TOWN OF PARADISE VALLEY

Smoke Tree Resort

Major Special Use Permit Amendment

Town Council Work Study Session #1

HEIGHT

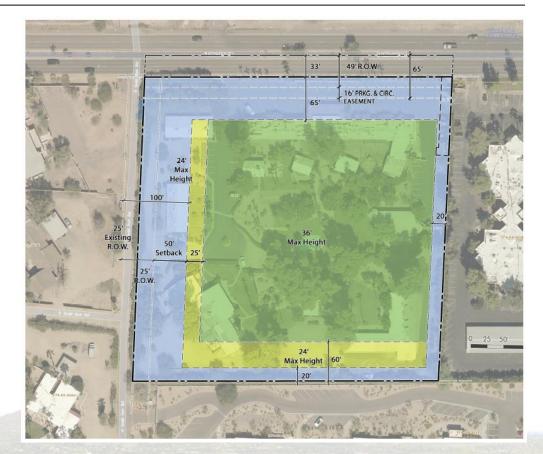
- Maximum height of 36 feet
- In certain areas, for mechanical screening, height can be increased up to 42' for up to 35% of the roof area
- Other allowed projections:
 - Elevator Enclosures 3'
 - Chimneys 3' (max of 15 total)
 - Towers or other architectural features – 3' (max of 8 total)

RIGHT-OF-WAY

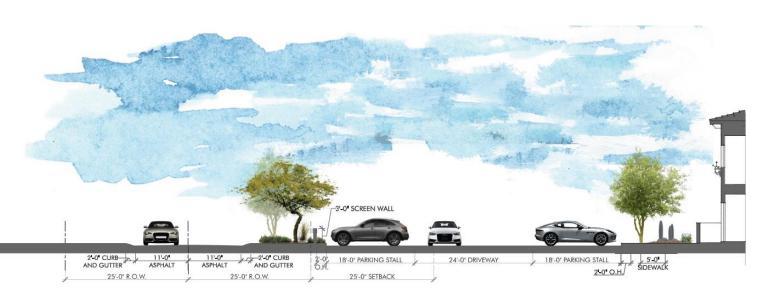
- Town Codes identify 25' on Quail Run and 65' on Lincoln
- Planning Commission recommended to Town Council for Lincoln Medical Plaza 49' of dedicated ROW and 16' of easement
- Applicant is open to multiple options
- Request to use ROW for Landscape buffers and Parking
- Impacts setbacks, Lot Coverage, FAR, etc.
- Full dedication of both Lincoln and Quail Run is approximately 25% of site
- Open to full dedication if relief is given from other SUP Guidelines

RIGHT-OF-WAY

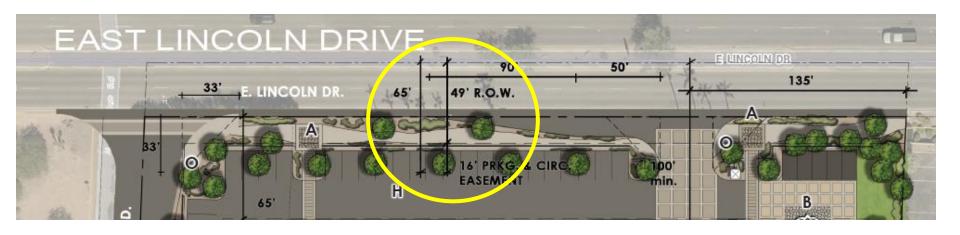
- Full improvements to both side of the road from intersection to southern driveway
- Showing 25' of ROW on Quail Run

IMPACTS TO ADJACENT USES

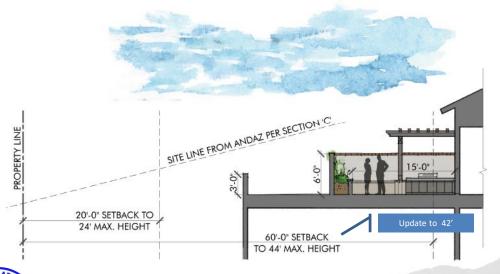
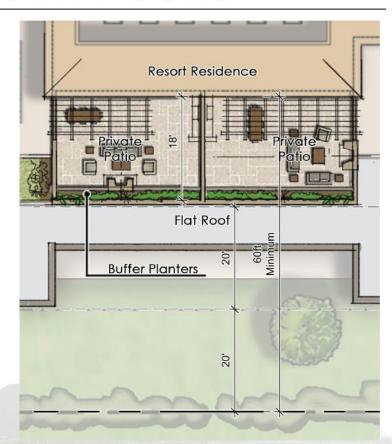
- Patios / Balconies removed from west property line
- South property line adjusted to not be seen from Andaz units

Lighting

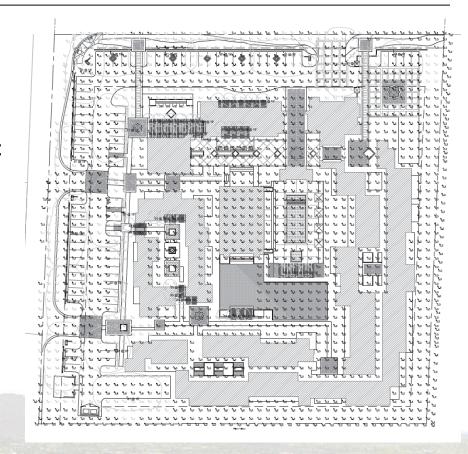
- To meet guidelines for Foot Candles and lumens
- Parking lot lights adjusted to be equidistant from property line as height of structure
- Light to be 3000K or less

IMPACTS TO ADJACENT USES

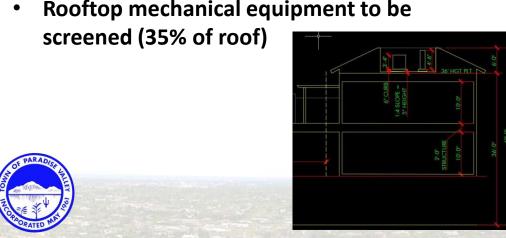
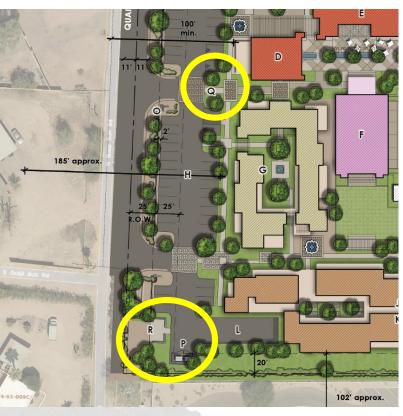
- Trash Collection and Employee break area located at the southwest corner of the site
- Deliveries occur on site, stipulation that they do not happen on Quail Run
- Three foot screen wall along western property line
